Block Diagram			
PROJECT:	asar_a7	REV:	9/2/2026 1:29:21 PM
AUTHOR:	Christian Tambe		Sheet: 1

X4
VBATT
BAT+
GND
JST PH 2-pin, 1S LiPo
Power Supplies
PROJECT: asar_a7
REV: 9/2/2026 1:29:21 PM
AUTHOR: Christian Tambe
Sheet: 2

STEMMA QT, I2C

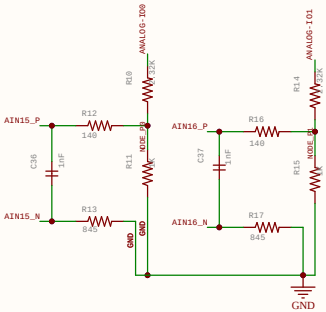
2026-09-10: BTN pads 1-2 are one switch terminal and 3-4 the other. They were one pin each ("1,2" and "3,4"), an EAGLE multi-pad import artefact that matches no Altium footprint pad; now four pins, each pad on its partner's net.

General IO			
PROJECT: asar_a7		REV:	9/2/2026 1:29:21 PM
AUTHOR: Christian Tambe			Sheet: 3

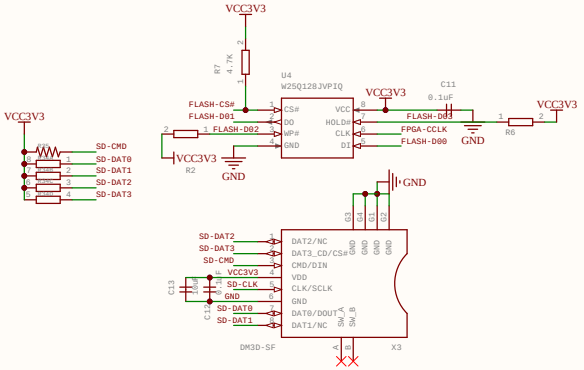
MASTER SPI BOOT (x4). M2:M1:M0 = 0:0:1 -- R20 pulls M0 to VCC3V3, R21/R22 pull M1/M2 to GND -- so at power-up the FPGA drives CCLK itself and clocks its bitstream out of U4 with no USB and no host present. That mode can only use the dedicated configuration pins: CCLK C11, FCS_B K19, D00_MOSI D18, D01_DIN D19, D02 G18, D03 F18. No other ball will do, which is why SDRAM A4 had to move off K19 (it is now on R3, bank 34). After DONE the six pins revert to ordinary user I/O. R2/R6 keep WP#/HOLD# high through the x1 command phase and through the float window before the FPGA drives D02/D03 (PUDC_B is tied high, so the FPGA has no internal pull-ups). R7 keeps FCS_B deselected. Vivado: set_property CONFIG_MODE SPIx4 [current_design] set_property BITSTREAM.CONFIG.SPI_BUSWIDTH 4 [current_design] The microSD is deliberately NOT on this bus any more: an inserted card sits in native SD mode watching bitstream traffic go past on what it believes is CMD, and one 48-bit window with a valid CRC7 is enough to make it answer and drive the line the FPGA is reading. X3 has its own CLK/CMD/DAT0 on V17/V16/W18 (bank 14), clear of the six master-SPI pins.

microSD runs the NATIVE 4-BIT SD BUS, not SPI. CLK, CMD and DAT0-DAT3 -- six signals, all in bank 14: CLK V17, CMD V16, DAT0 W18, DAT1 H19, DAT2 P17, DAT3 W16. DAT3 is the old SPI chip-select, which needs no new pin. R34/R35 are the 4.7k pull-ups the SD spec requires on CMD and DAT0-DAT3. R9 (100R on DAT0 only) was removed: one damped line out of four is a skew, not termination.

2026-09-06: X3 is now the Hirose DM3D-SF push-pull socket (HRS 609-0025-8), DM3 catalog p9. Same 8-contact pinout; shell pads G1-G4 to GND; card-detect switch A/B (closed with card) left open. Needs its own footprint on the PCB.

Memory			
PROJECT: asar_a7		REV:	9/2/2026 1:29:21 PM
AUTHOR: Christian Tambe			Sheet: 4

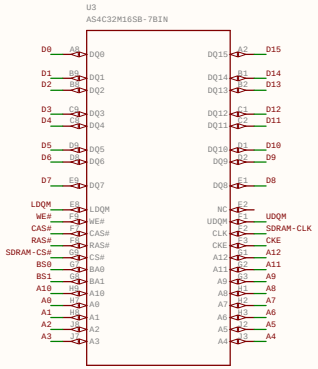
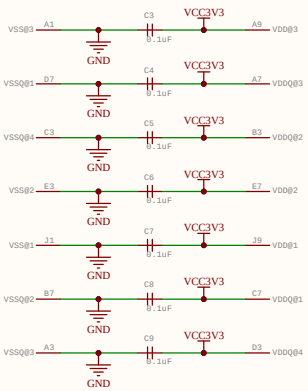
U3 = AS4C32M16SB-7BIN: 512Mbit (32M x 16) = 64MB, 54-ball FBGA, 8 x 8 mm, 0.8 mm ball pitch. The column address is A0-A9 (1024 columns): the memory controller must be set to 10 column bits, or it reaches only half the array. Row A0-A12, banks BA0/BA1, refresh 8192 cycles / 64 ms. -7BIN: 143 MHz max at CL3, tRCD/tRP 21, tRC 63 ns, TA -40 to 85 C (industrial), IDD1 max 110 mA.

U3 DECOUPLING -- U3 is the 54-ball FBGA. Each supply ball has a ground of its own domain at the mirror position in its row: VDD A9/E7/J9 to VSS A1/E3/J1, VDDQ A7/B3/C7/D3 to VSSQ A3/B7/C3/D7. Alliance isolates VDDQ from VDD for DQ noise immunity; on this board both are VCC3V3 and both grounds are GND. C3-C9, C11 and C12 (0.1 uF) and C13 (10 uF bulk) are on the bottom side under U3. Do NOT split the ground plane.

FPGA Connections			
PROJECT: asar_a7		REV:	9/2/2026 1:20:21 PM
AUTHOR: Christian Tambe			Sheet: 6

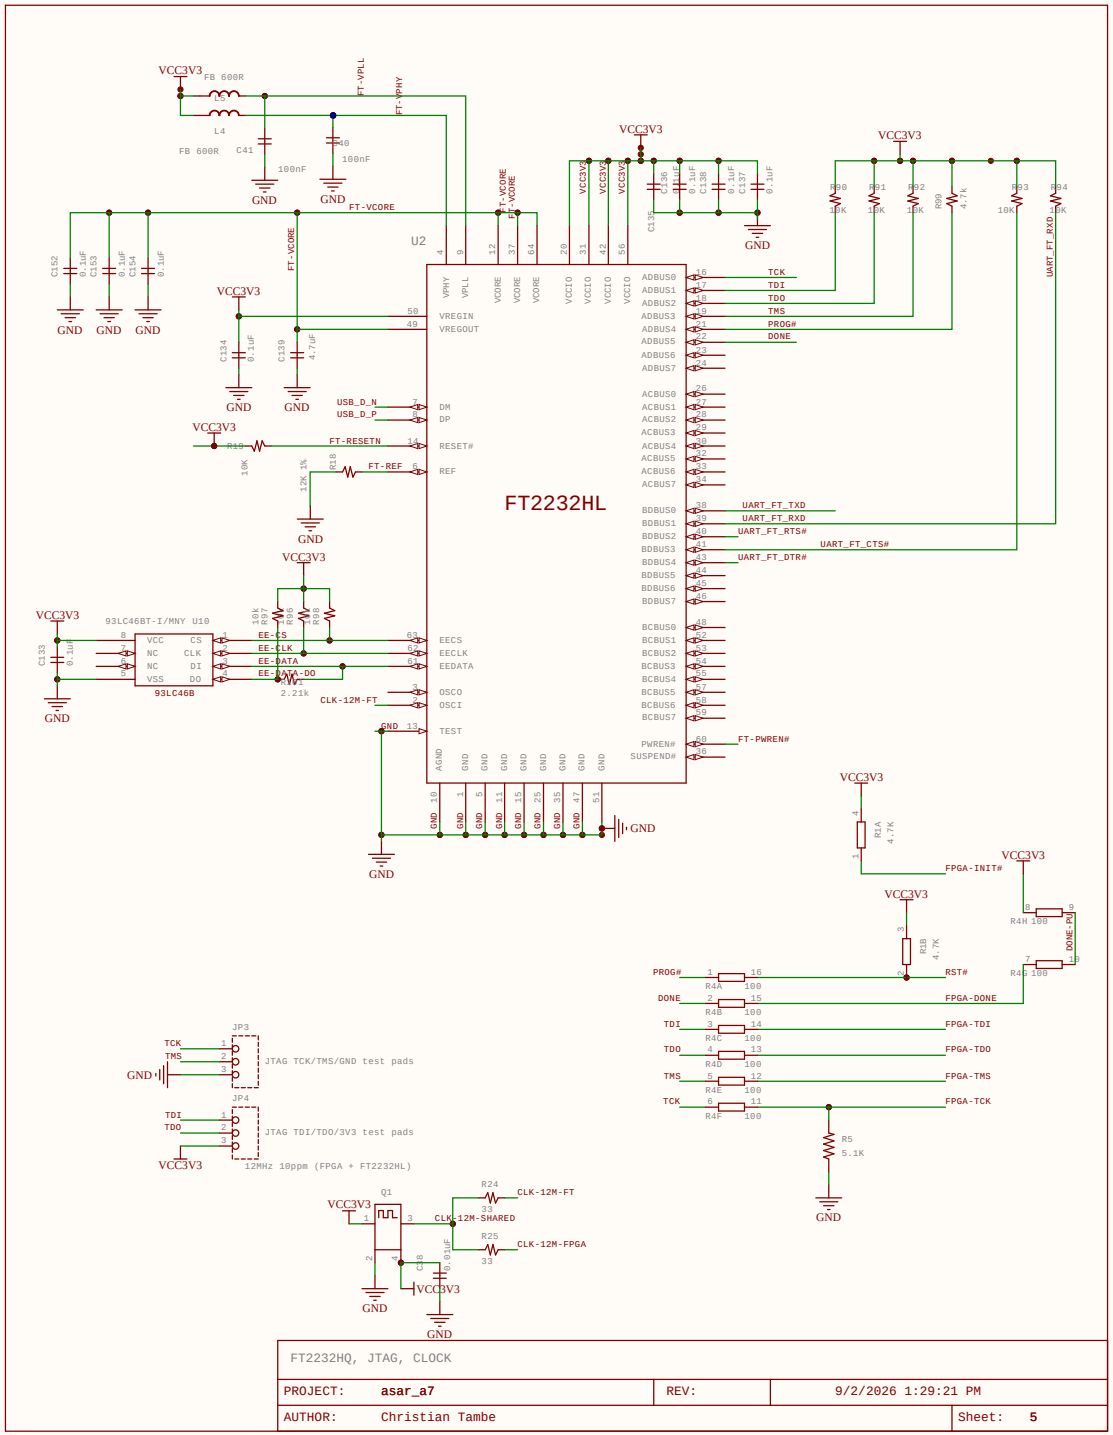
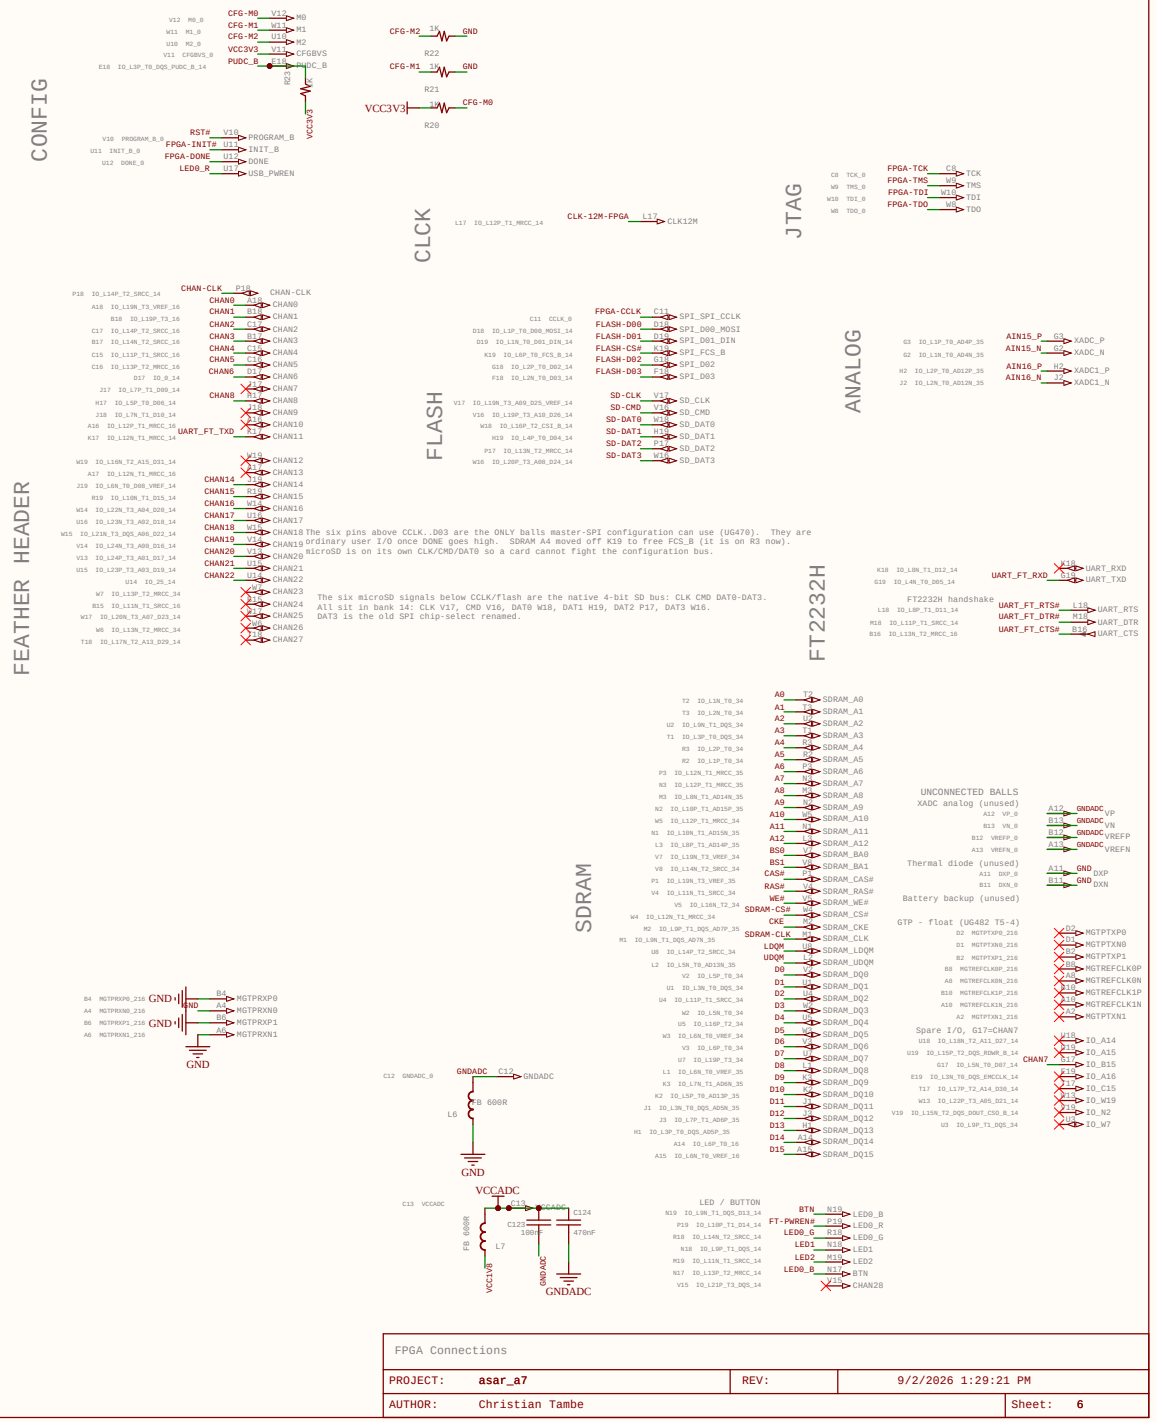
The six pins above CCLK..D03 are the ONLY balls master-SPI configuration can use (UG470). They are ordinary user I/O once DONE goes high. SDRAM A4 moved off K19 to free FCS_B (it is on R3 now). MicroSD is on its own CLK/CMD/DAT0 so a card cannot fight the configuration bus.

The six microSD signals below CCLK/flash are the native 4-bit SD bus: CLK CMD DAT0-DAT3. All sit in bank 14: CLK V17, CMD V16, DAT0 W18, DAT1 H19, DAT2 P17, DAT3 W16. DAT3 is the old SPI chip-select renamed.
